**SSD 31515622- Eastern Creek Quarter Stage 3- Retail Outlet Centre**

# Blacktown City Council submission

## SSD 31515622 - Eastern Creek Quarter Stage 3 Detailed Design – Retail Outlet Centre

Diamond Planters

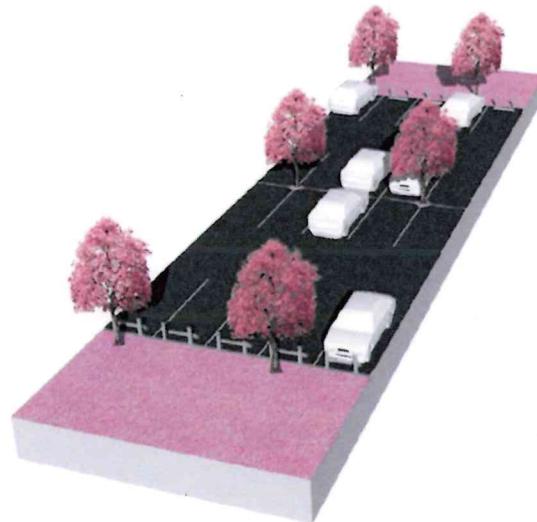
- 1.1 The roof of the Retail Outlet Centre must utilise high albedo and high emittance roofing materials and be light coloured in accordance with Blacktown City Council's Responding to Climate Change Strategy (<https://www.blacktown.nsw.gov.au/About-Council/What-we-do/Environmental-Plans-and-Policies#section-2>). Please confirm roof materials and finishes.
- 1.2 Additionally, all internal roads and hardstand surfaces should also utilise high albedo and high emittance colours and materials to mitigate urban heat.
- 1.3 The at-grade carpark area is to incorporate more tree planting at a rate of 1 tree per 3 parking spaces to assist with heat mitigation in the Western Sydney context.
  - The larger carpark fronting Church Street is of particular concern and requires further tree planting. Amended plans should consider utilising diamond planters of similar effect to increase canopy cover
